Re: H-King A-1 Skyraider 800mm (31.5")
PNF w/ORX Flight Stabilizer incorrectly
installed.

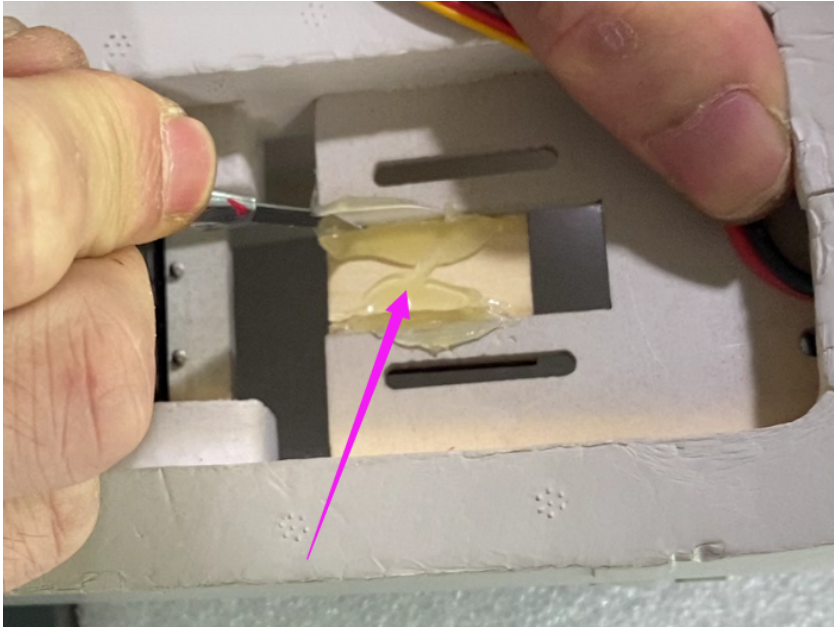
1. Use a hobby knife to cut off the set of zip ties that secures the ORX stabilizer.

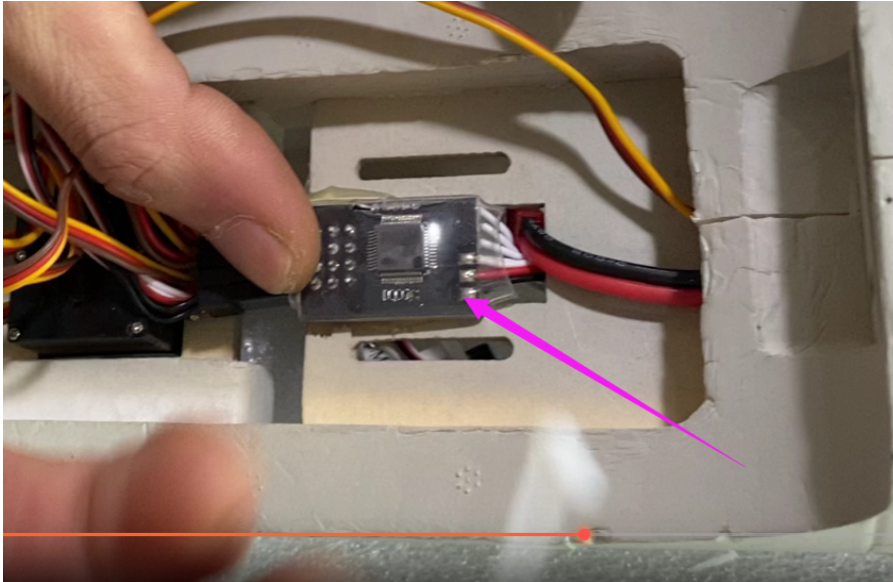
2. Remove the hot glue residue and the plywood plate as shown.

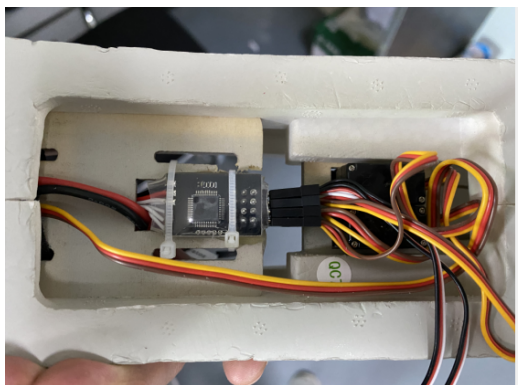
3. Flip the ORX stabiliser 180° and secure it on the tray with 2 zip ties.

4. The ORX stabilizer should be installed on the tray with zip ties to secure it in place as shown.
